SCI-823-0.00

SR 823 OVER CSXT RAILROAD

PRELIMINARY DESIGN REPORT SUBMITTAL

Mr. Jawdat Siddiqi, PE
Office of Structural Engineering
Ohio Department of Transportation
1980 W. Broad Street
Columbus, Ohio 43223**SUBJECT: Preliminary Design Report Submittal
SR 823 over CSXT Railroad
SCI-823-0.00 Portsmouth Bypass
PID#77366**

TRANSVERSE SECTION
 BRIDGE NO. SCI-823-0214 L&R
 SR 823 OVER CSXT RAILROAD

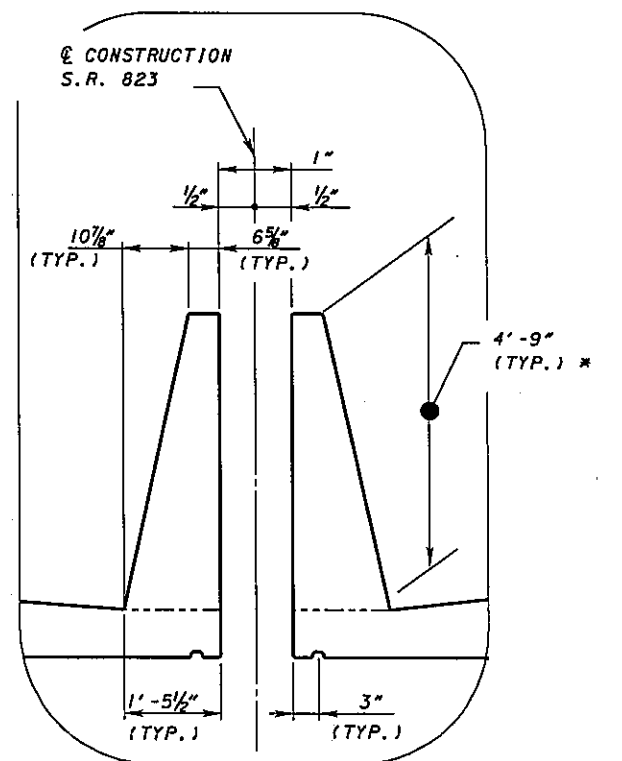
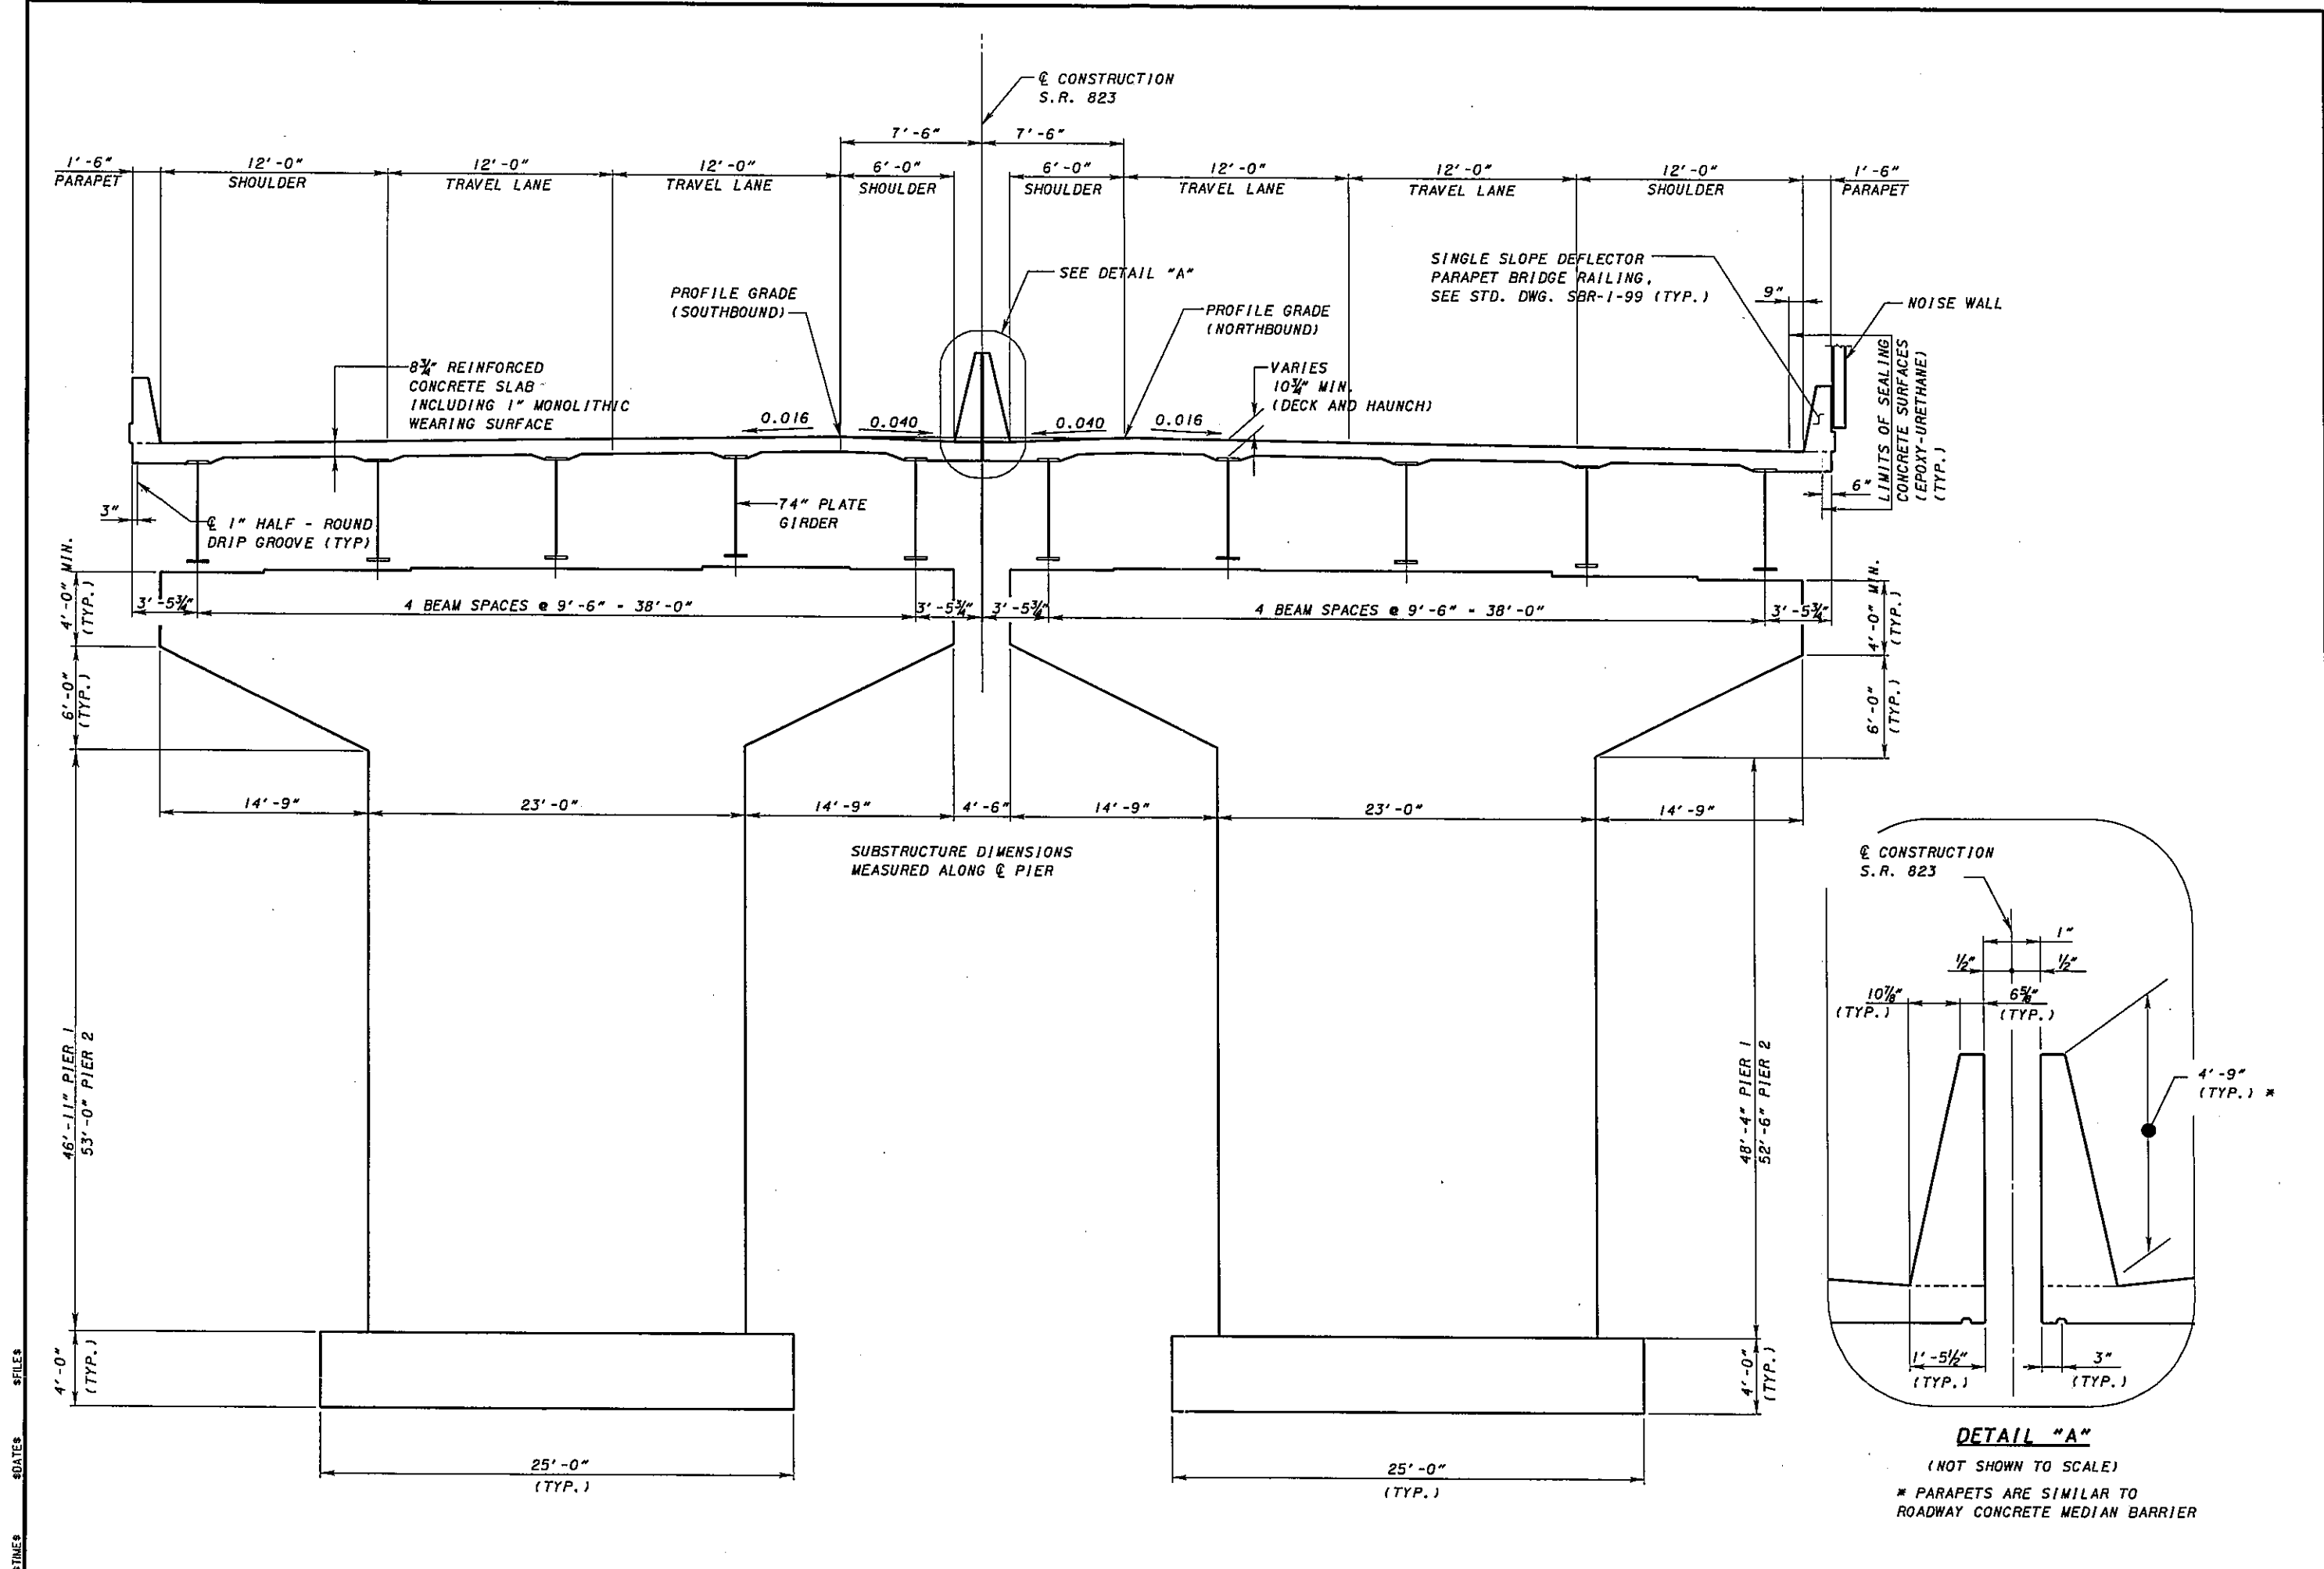
3. *Verify the height of the T-type pier stems shown on Transverse Section – Alternative 1.*

The heights of the pier have been checked and revised as required.
